Access Compliance Report

Public Rights-of-Way

(Curb Ramps)

Intersection ID: 2527	Main Street: CAMBRIDGE_BAY_DR	Cross Street: LAGRANDE_DR	Location: SE
ADA ID: B1D1EB66775C	Ramp Type: PerpDiag	Initial Pass/Fail: Pass	Overall Compliance: No
Severity Score: 7.75			
Codes/Mitigation Info/Possible Solution		Field Measurements/Component Compliance

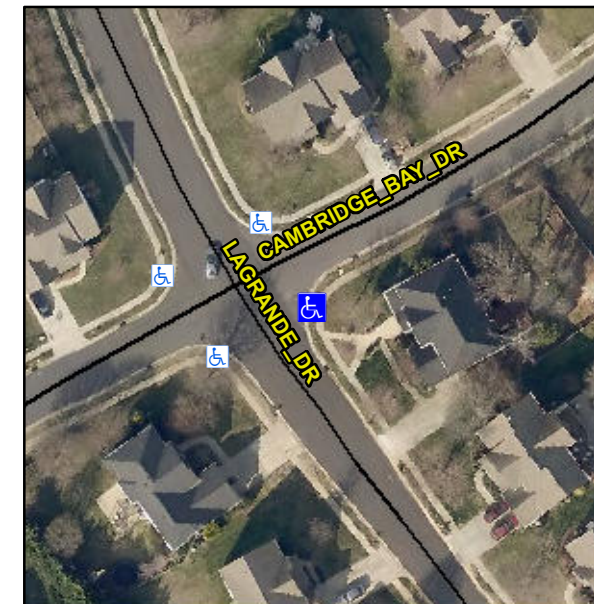
Remove & Replace Curb Ramp With Two New Directional Ramps or Equivalent. Grind Gutter Lip.

R304.5.3, R304.2.2-Perp, R304.3.2-Para, R305.2, R302.7, R302.7.2
